**Internal Development Approvals Committee
meeting**

MINUTES

**held on Wednesday 9 June 2004 at 6.00 pm
at the Richmond Town Hall Meeting Room 3**

1. 200-208 Noone Street, Clifton Hill – Planning Permit Application No. PL03/1299 (Part demolition, alterations and additions for the construction of 14 dwellings and partial waiver of car parking).

Revised Plans

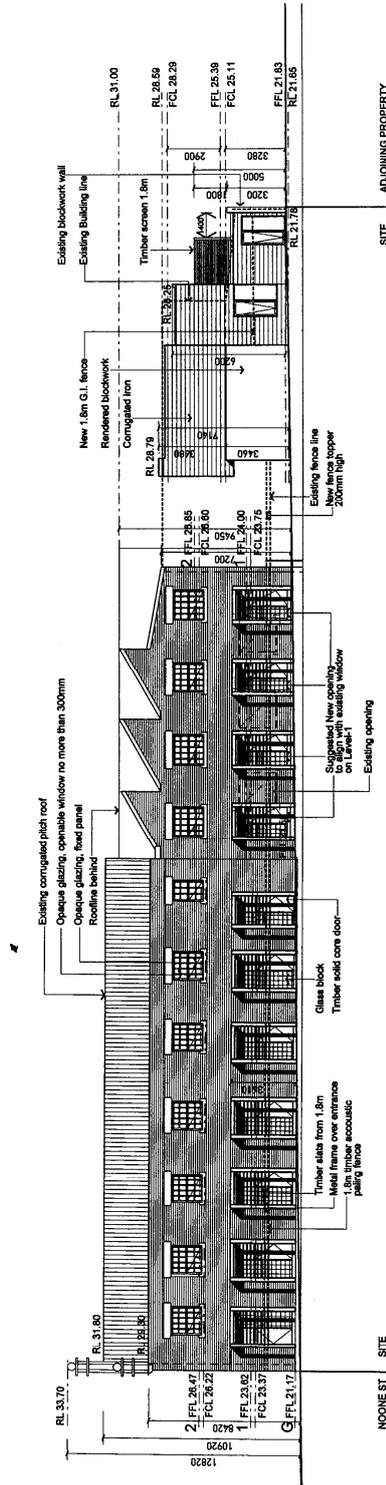
91. Along the east elevation, where the new building is proposed, the first floor has a setback ranging from 800mm to 1.6 metres (in accordance with the schematic plans received 12/5/04). Where the first floor is setback 800mm from the boundary the height of the wall is 7.1 metres. In accordance with Standard B17, at 7.1 metres high the wall should be setback 2.2 metres. While it is acknowledged that the proposed setback does not comply with the above Standard it is considered to comply with the objective as this section of wall does not adjoin any area of useable secluded private open space and a utilitarian storage shed currently exists to the east where this section of wall is proposed.

92. Along the east elevation, where the wall height reduces to 6.2 metres, the schematic plans (received 12/5/04) show this wall setback 1.6 metres from the boundary. In accordance with Standard B17 a 6.2 metres high wall should be setback 1.7 metres from the boundary. This section of non compliance is minimal and is considered acceptable.

97. To the east elevation, in accordance with schematic plans (received 12/5/04) a new boundary wall is proposed to a height of 3.4 metres at a length of 6.2 metres. This wall will predominantly adjoin a neighbouring shed's wall and is therefore considered appropriate.

112. At second floor, along the east elevation, new bedroom windows are proposed. In accordance with the schematic plans (received 12/5/04) these windows will have opaque glazing, with the upper pane being top hung and only openable outwards 300mm. This level of screening is considered acceptable and will ensure no overlooking.

- (k) the east elevation of the first floor terrace area of dwelling 14 to be screened in accordance with Standard B22 of clause 55 (ResCode), to the satisfaction of the Responsible Authority. The screen detail to be submitted;

Revised Plans

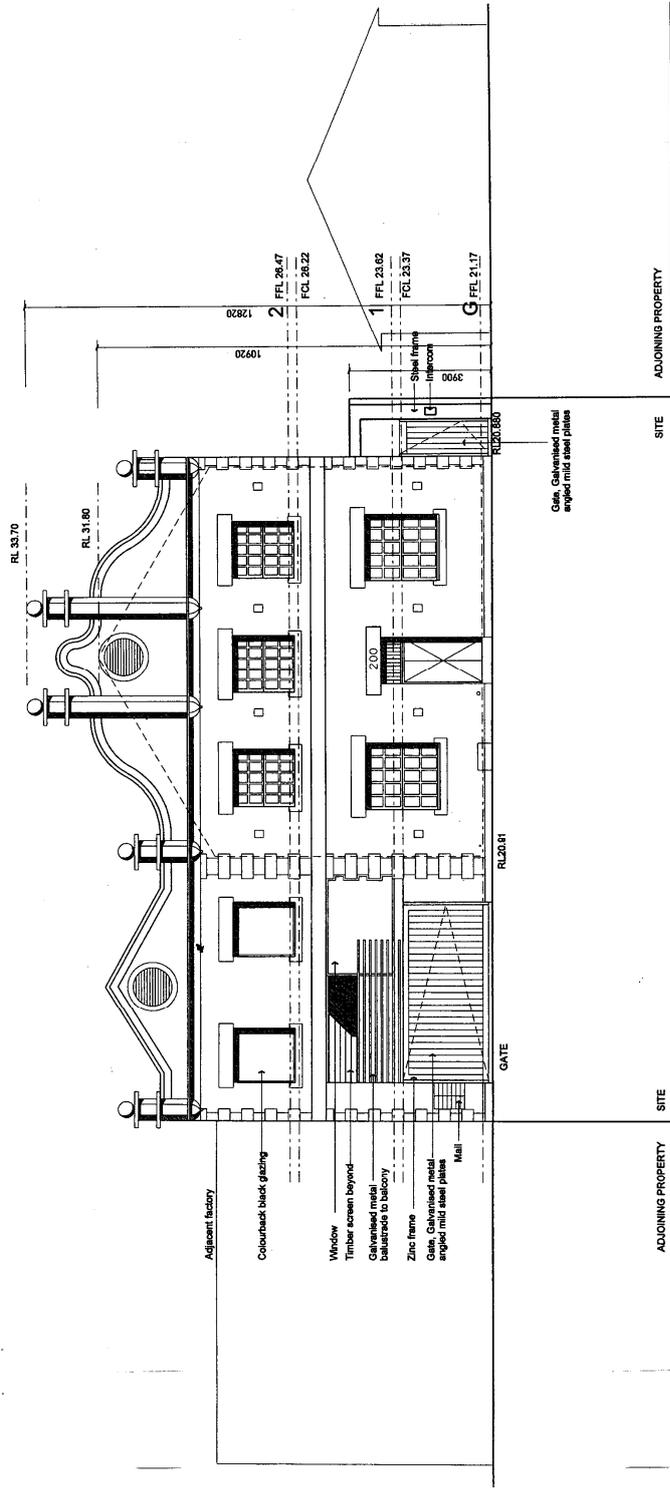
144. In relation to point (a) the applicants have indicated that the existing multi-paned window frames in the south façade and side elevations within the upper levels will be retained. A condition will be included on the permit requiring this notation of the plans.

- (g) a notation to be included on the elevation plans that the existing multi-paned window frames, along the south face and the side elevations at the upper levels, are to be retained, to the satisfaction of the Responsible Authority;

- (h) the south elevation to show the retention and refurbishment of the existing roof sign 'dye work', to the satisfaction of the Responsible Authority;

Revised Plans

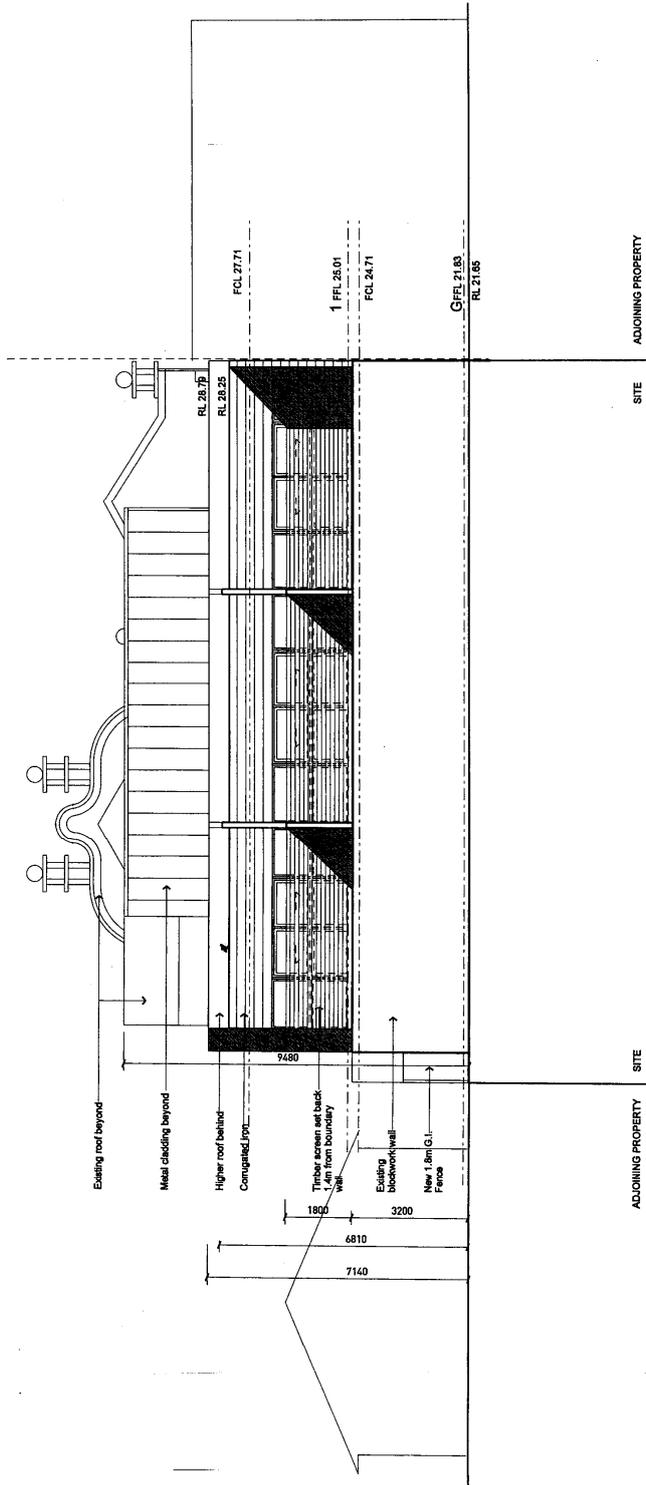
90. In accordance with the schematic plans received by Council on 12 May 2004, the first floor deck areas will be setback 1.4 metres from the north boundary, at a height of 5 metres. In accordance with Standard B17, a 5 metre high wall should be setback 1.4 metres from the boundary, therefore the proposed height/ setbacks from the north comply with Standard B17.

109. At first floor, along the north elevation, terrace areas are proposed to dwellings 12 to 14. The schematic plans (received 12 May 2004) show a timber screen along the north elevation of these terrace areas however no details of the level of transparency and whether the screens will be fixed have been noted. A condition will be included requiring that these terrace areas be screened in accordance with Standard B22.

- (i) the skylight to be traditional Deluge gel framed, or similar, to the satisfaction of the Responsible Authority;
- (j) the north elevation of the first floor terrace areas of dwellings 12 to 14 to be screened in accordance with Standard B22 of clause 55 (ResCode), to the satisfaction of the Responsible Authority. The screen detail to be submitted;
